PTU PUNJAB
TECHNICAL
UNIVERSITY

PTU/EC/110

Dated 10.02.2015

Concept plans and Estimate for setting up sports hostel at main campus, Kapurthala.

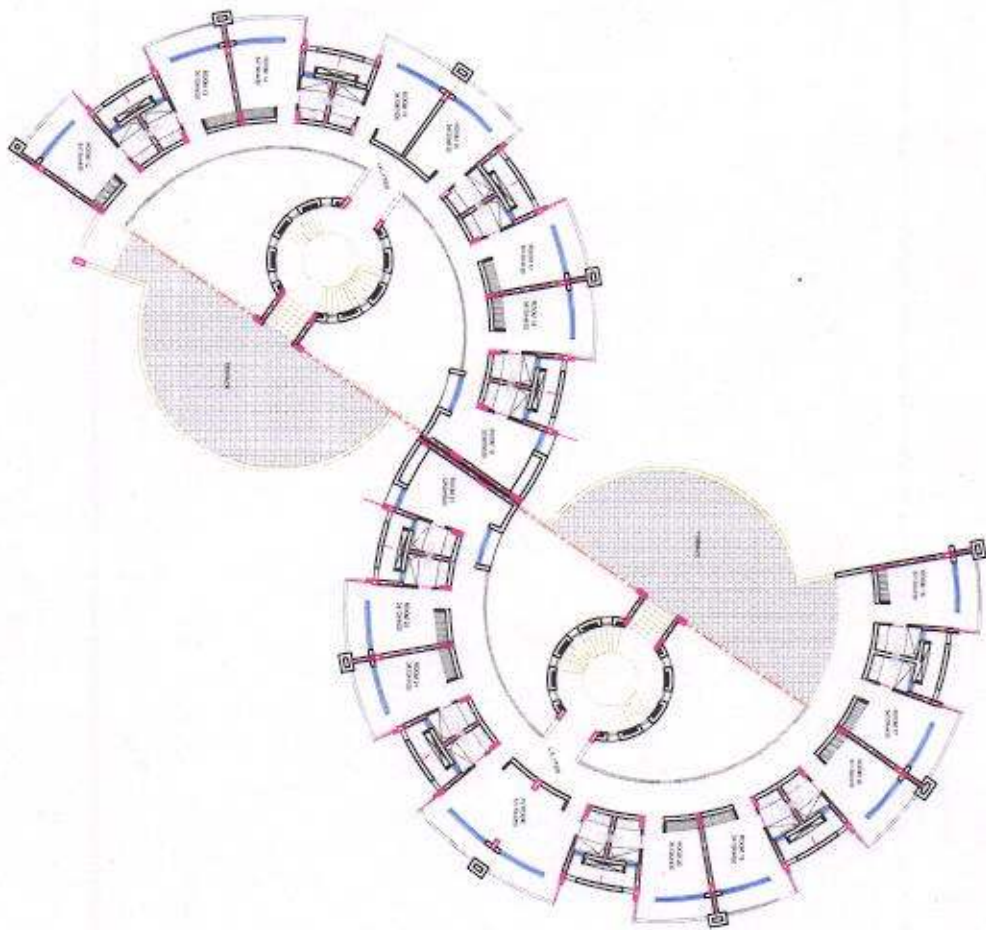
Agenda	Decision
<p>On the basis of conceptual plans approved by building committee for the proposed auditorium and hostels proposed at main campus, Kapurthala, the building plans for these buildings have been approved by Chief Town Planner, Punjab. Before taking up the construction for these buildings, Environmental clearance (EC) from Ministry of Environment and Forest is to be taken. It is to inform that while submitting application for EC, an undertaking, wherein some commitments towards safety measures during execution, control of pollution, facilities & amenities to workers, social responsibility towards workers engaged etc. is submitted and most of these are to be made during execution only. Since, the execution of these works is to be done by PWD, it is proposed that EC for these buildings is taken by PWD so that they are aware of the commitments and are followed during execution.</p> <p>The matter is placed before the Committee for discussions and decision please.</p>	<p>In view of the notification dated 22.12.2014 issued by 'Ministry of Environment, Forest and Climate Change' presented in the meeting, committee noted that Environmental Clearance for building construction projects for educational institutes is not required. However, committee advised PWD/PTU to confirm the same before start of any new construction activity.</p>
